RE: 05RFPPROVPRK-B, Providence Park Remediation Project-Phase I

Addendum No. 2

This Addendum forms a part of the contract documents and **modifies** the original ITB documents as noted below:

- **Attached CSR Report**
- **EPD Comments on the CSR**
- **Maps**

Figure 2

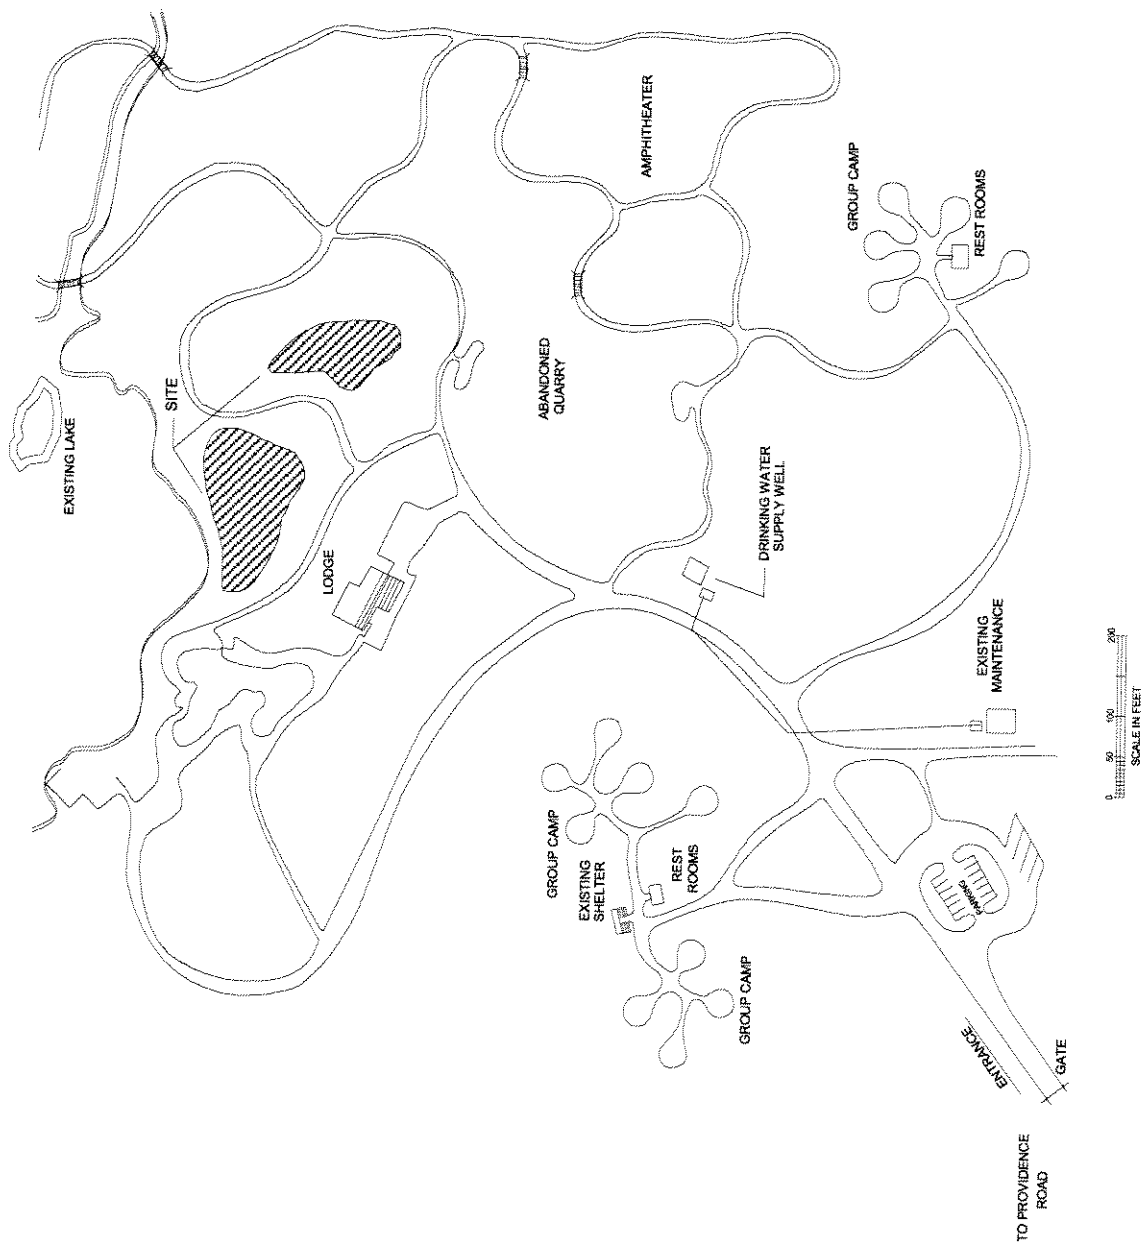
11. In the analytical tables, the laboratory-reporting limit (RL) is reported as the detection limit for metals in soil and VOCs, SVOCs, PCB, pesticides, herbicides, and metals in groundwater; and the laboratory method detection limit (MDL) is reported as the detection limit for VOCs, SVOCs, PCB, pesticides and herbicides in soils. Please revise all tables to include the "Reporting Limit" as the detection limit.
12. Different source areas are identified in Figure 2, Section 4.1 and Figure 3, and Section 4.1.2 and Figure 9. Provide a figure that identifies and labels the entire source area(s). Please depict on the figure the areas where drums were found and removed.
13. Please include park boundaries on Figure 2 Area Map.
